Downsview Road - Parking Changes

Changes proposed in this road:

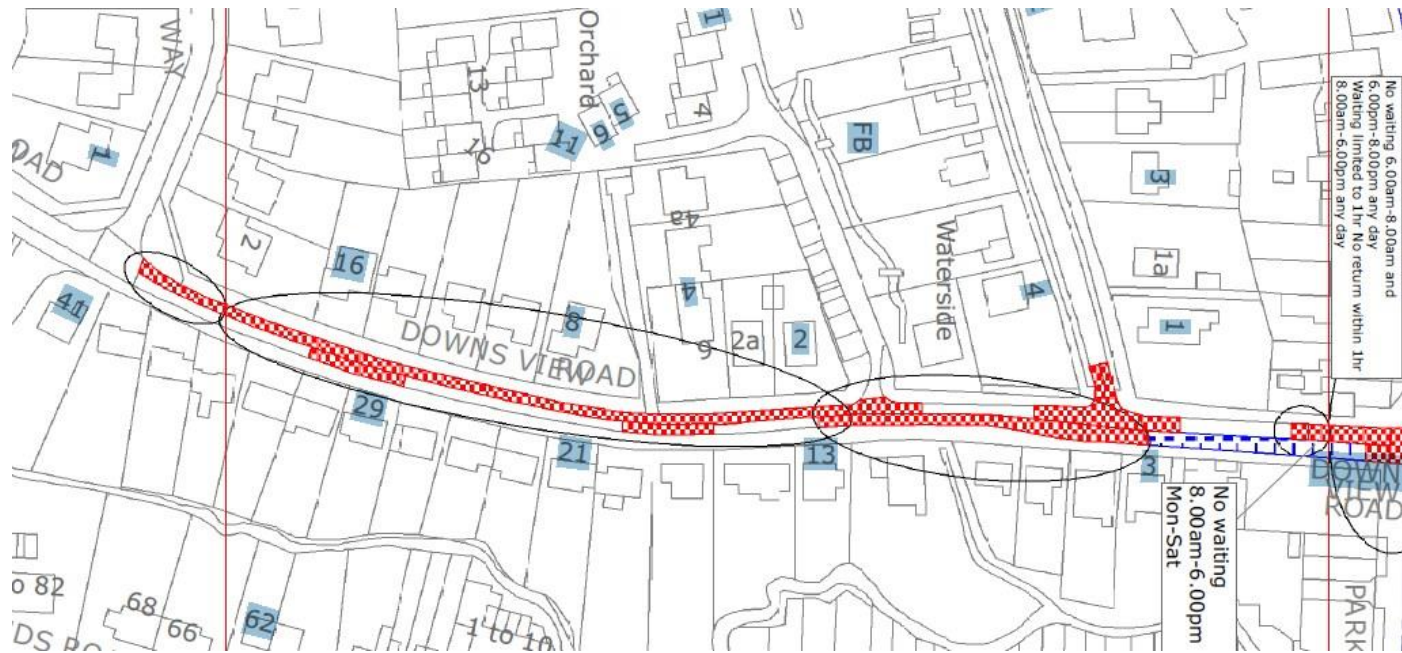
1. Due to issues with vehicles passing one another on this section of road, it is proposed to have a No Waiting restriction on the west side of the road with a couple of short lengths of yellow line on the east side of the road to allow passing places. This will extend to Ockenden Way, where there have been fewer parking problems identified.
2. Furthermore it is proposed that the lines at the top of the road (adjoining Keymer Road) are changed from single to double as this is becoming a dangerous crossing point.
3. The main part of this plan is to ease parking congestion and to help Public Service vehicles
